# ADDENDUM No. 1

## RFP No. 23-59

### East Medical Center Drive Bridge Rehabilitation and Widening Project

DRAWING NO. 2021-008-UT6

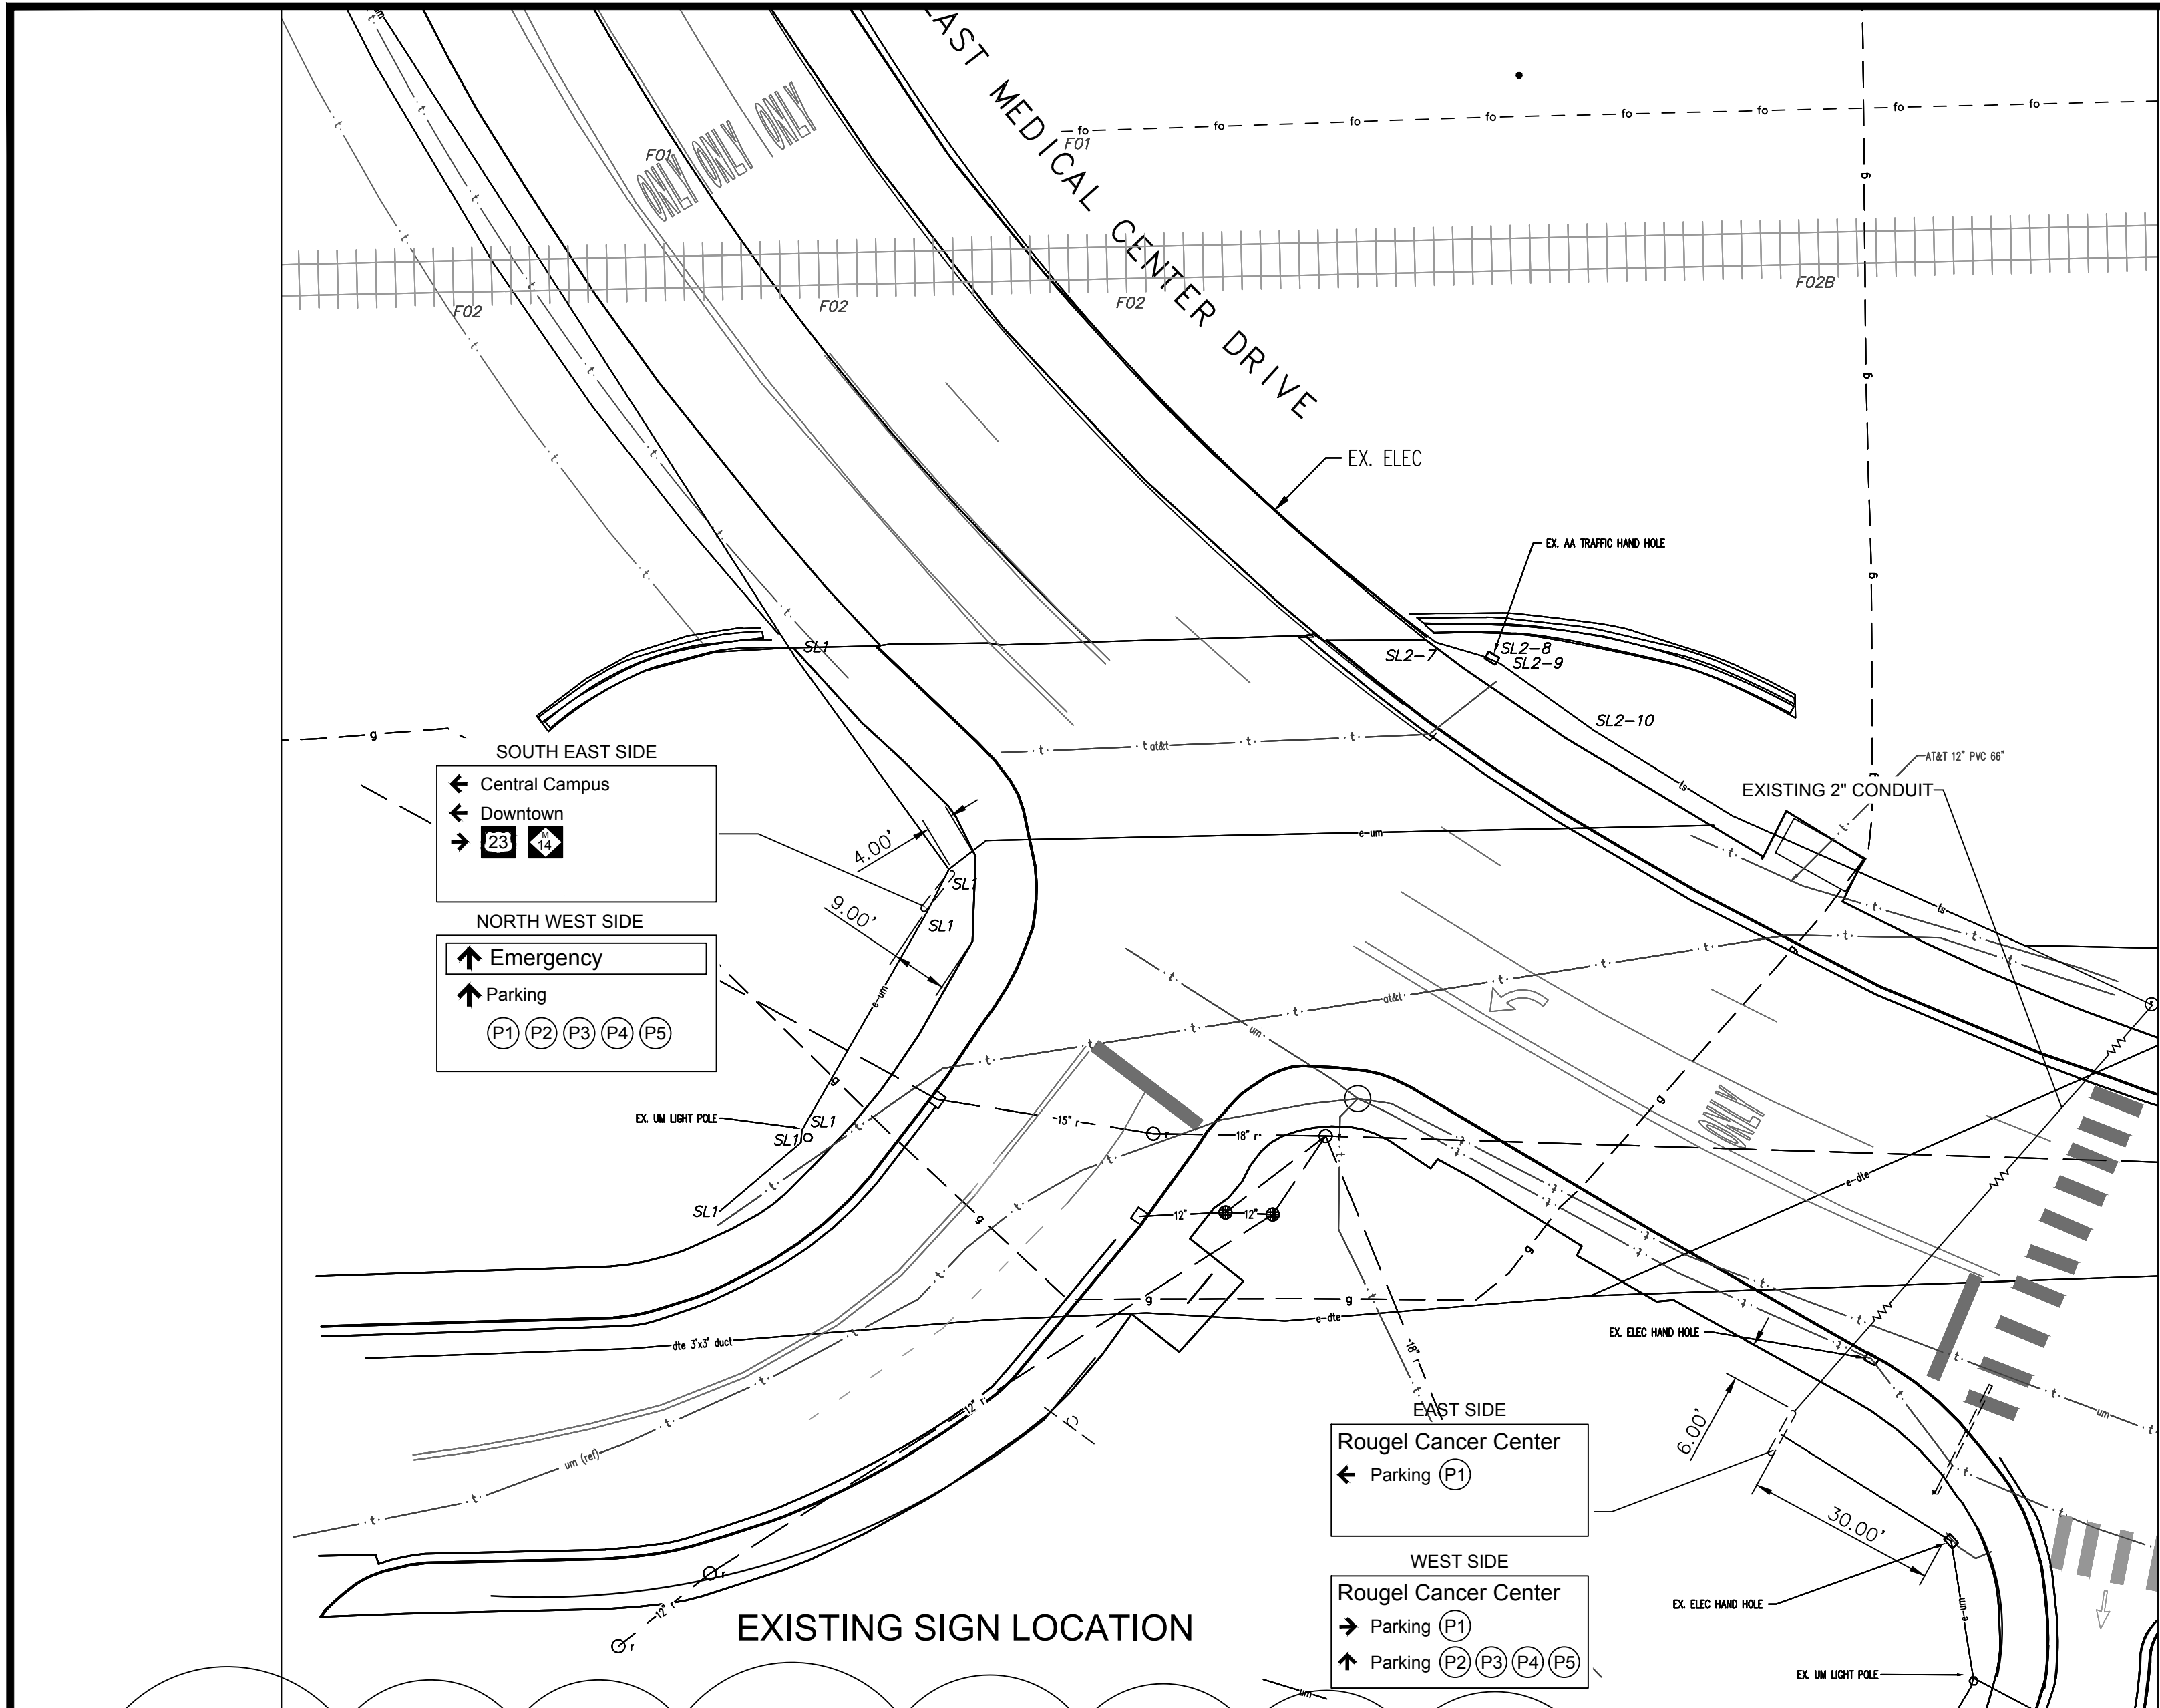
Question 28: Street light phasing plan, Note 8 states: UM TO PULL WIRING THROUGH UM SCHEDULE 80 PVC CONDUITS, CONTRACTOR TO COORDINATE WITH UM  
- there are no UM schedule 80 conduits in this drawing. Please confirm if the intention is for UM to pull their lighting cables from the sign to UM HH #6 in the noted schedule 40 conduit.

Street light phasing plan, Note 2 states: CONTRACTOR TO INSTALL SCHEDULE 80 PVC CONDUIT FROM EXISTING CITY OF ANN ARBOR HAND HOLE THROUGH CITY OF ANN ARBOR HH#2 AND TERMINATE IN CITY OF ANN ARBOR HH#4...

Answer 28: Note 8 has been updated to "...schedule 40 PVC conduits...". Note 2 has been updated to "...schedule 40 PVC conduit...".

SHEET NO. 63 OF 155

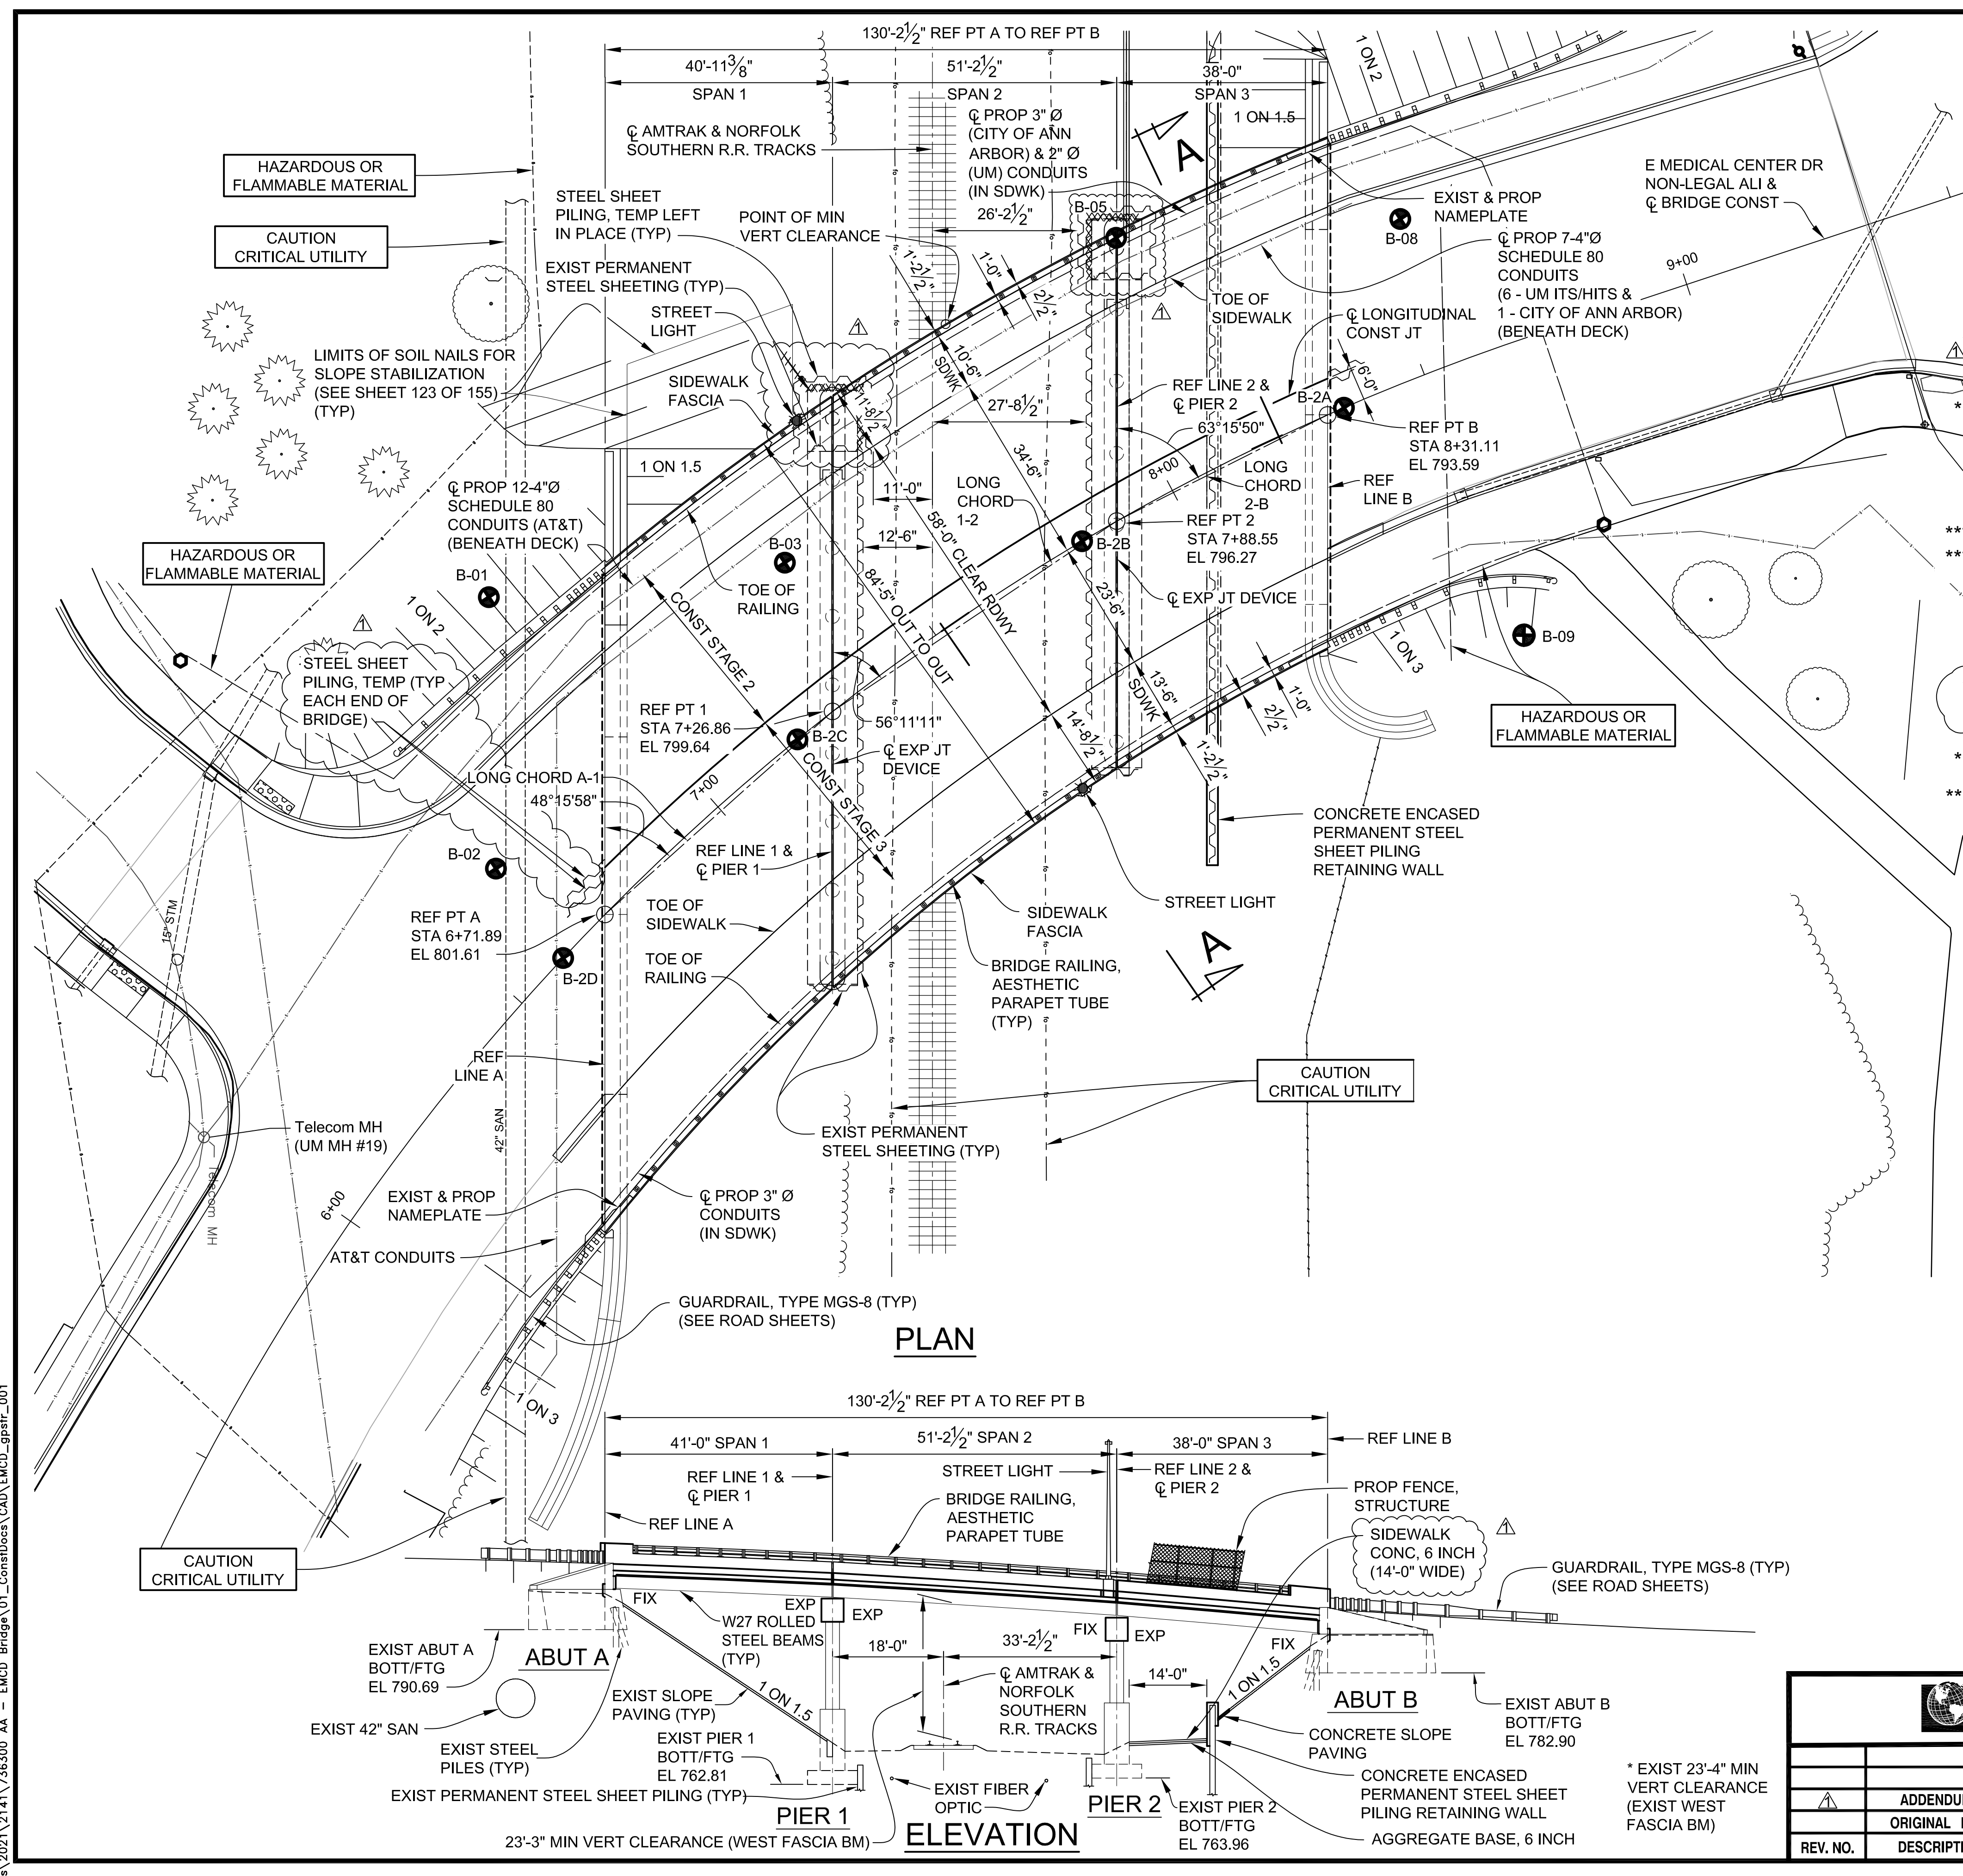
Question 20: Please provide details for the sign foundations.

Answer 20: Sign foundation details have been added to Sheet 63.
